23/04932/X | Application for the variation of conditions 8, 9 & 17 of permission 21/01999/F Erection of 62 dwellings with associated parking, new vehicular access, and associated infrastructure and landscaping. | Former Car Park College Road Clifton Bristol BS8 3HX.

Figure 2: Detail of the Proposed Ground Floor Plan<sup>1</sup>

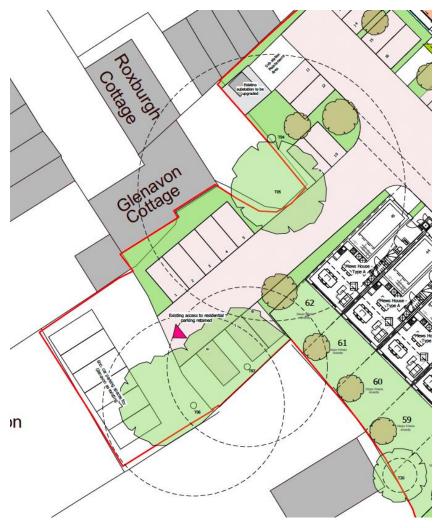
We remain concerned that the proposed ground and building works will fall within the root protection areas (RPAs) of these three trees. These works comprise roads, hardstanding and, in the case of T05, foundations and the building above. The canopies of trees T06 & T07 also oversail the proposed roads and hardstanding, which also risk damaging them.

Ideally, these structures should not be placed within the RPAs of any of these trees in the first place. If a 'significant adverse impact' cannot be avoided, then the application should be rejected.

However, if it is considered that the construction of permanent hard surfacing, foundations and buildings within these RPAs is indeed 'achievable without significant adverse impact', the applicant needs to explain why this is so and set out the construction methodology to be used. This has not been done.
